ADDENDUM NO. 5
NEW SOFTBALL COMPLEX FOR TRUSSVILLE CITY SCHOOLS
Architect Job No. 23-72
April 17, 2024
DCM # 20240224

The Plans and Specifications are here by amended. The following supersedes all contrary and/or conflicting information and is made part of the contract documents.

JOB NO. 23-72
SHEET NO. C5.1

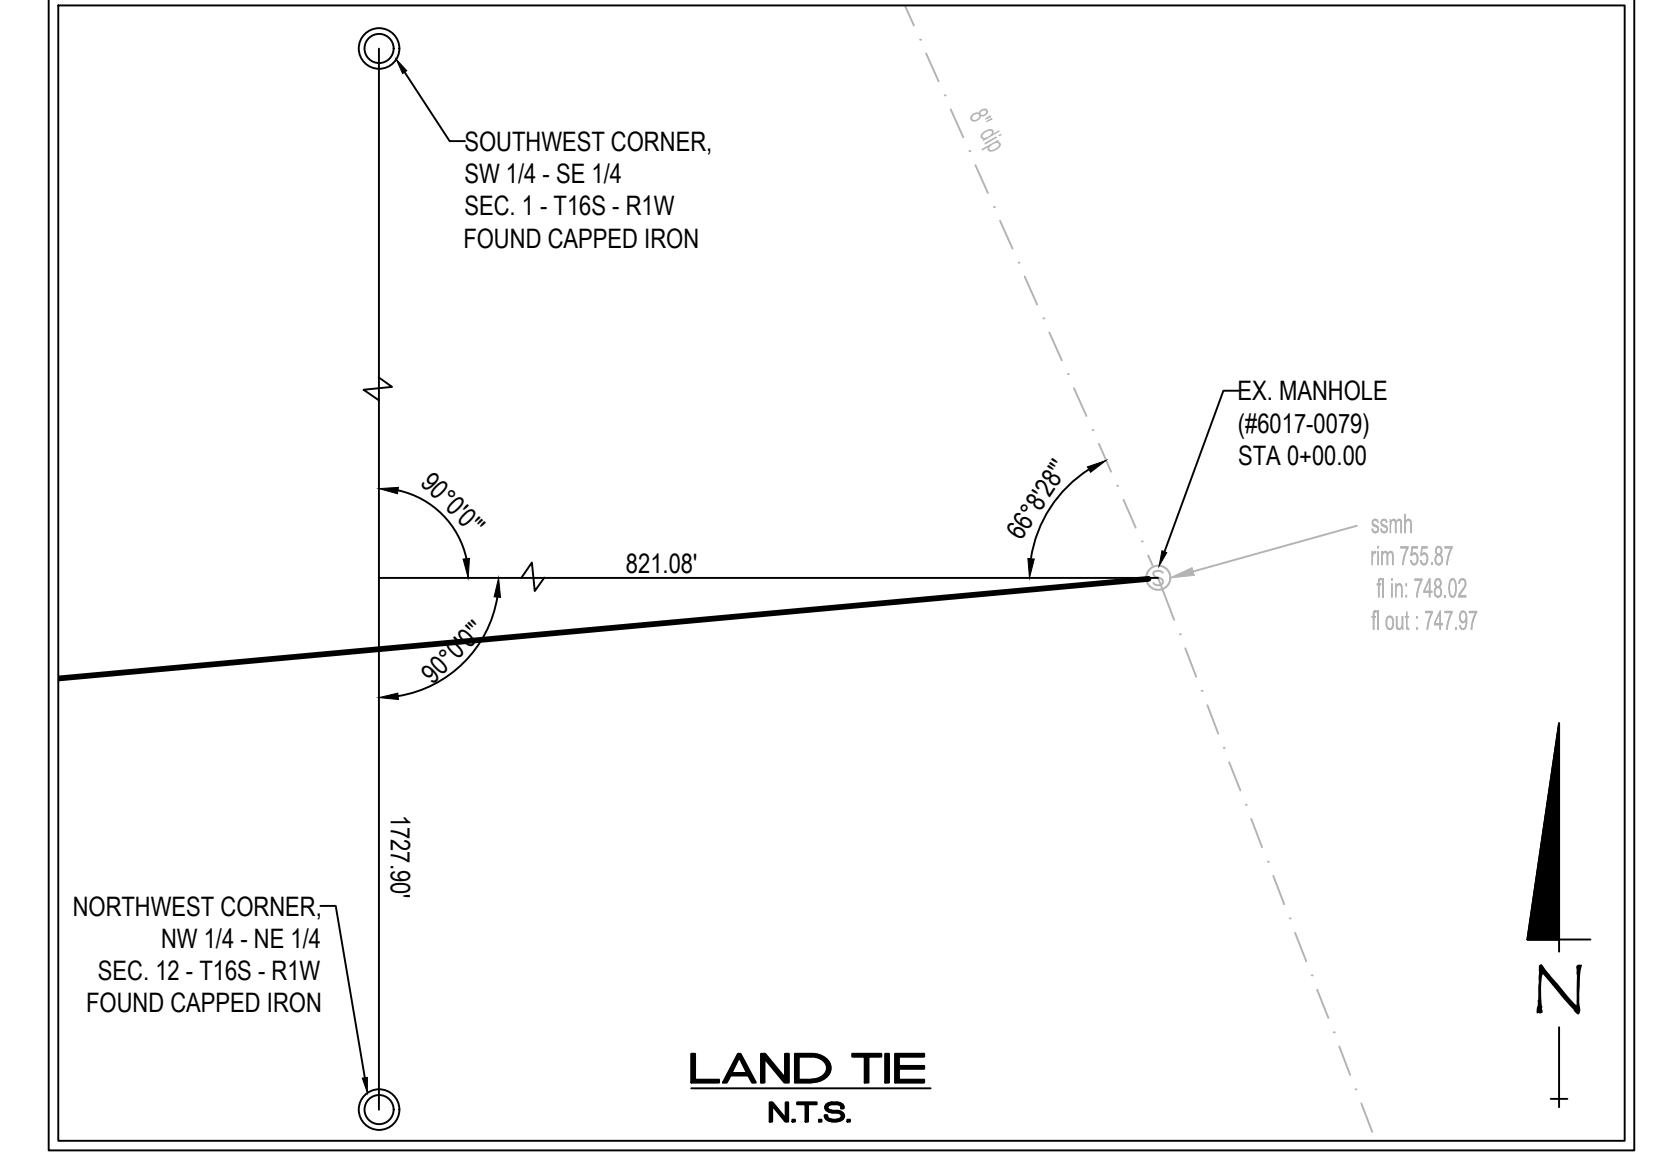
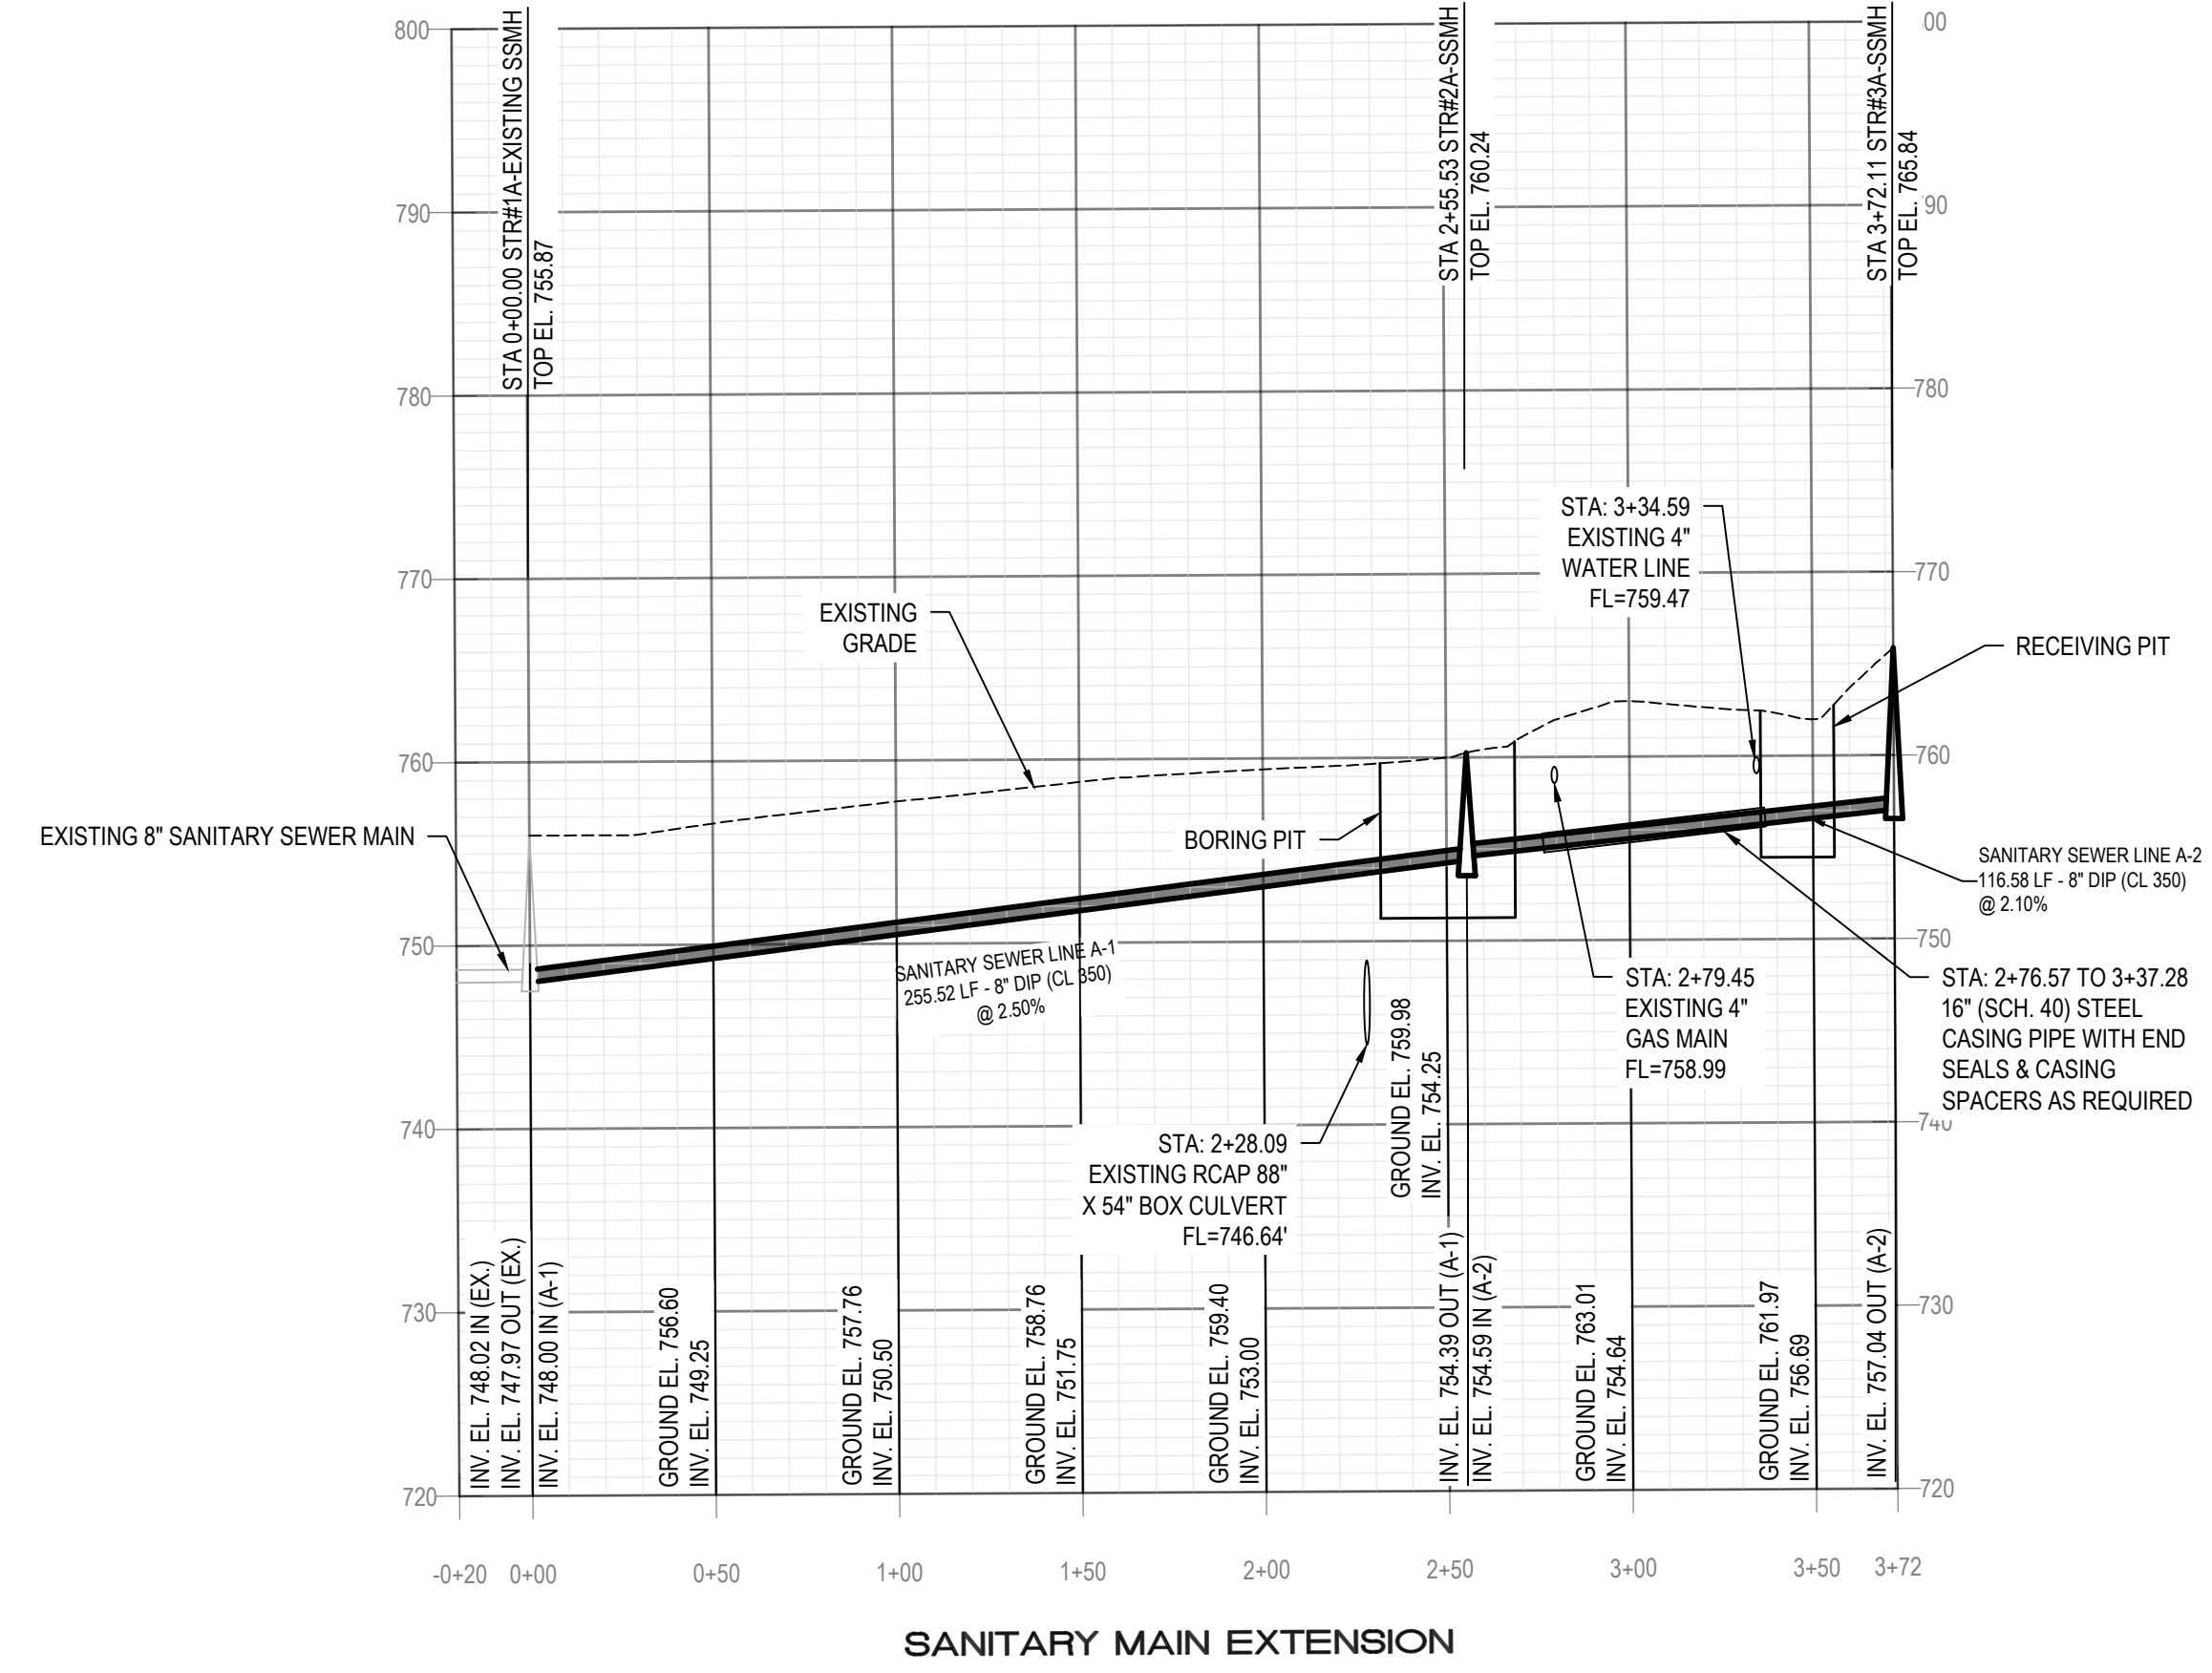
- 1. See the attached REVISED Sheet **C0.1** for revisions to Civil Notes.
- 2. See the attached REVISED Sheet **C5.0** for revisions to Site Utility Plan.
- 3. See the attached REVISED Sheet **C5.1** for revisions to JCES Plan & Profile.
- 4. See the attached REVISED Sheet **A2.5** for revisions to Door and Window Schedule and Details changed finish and operation of coiling service door on the schedule.
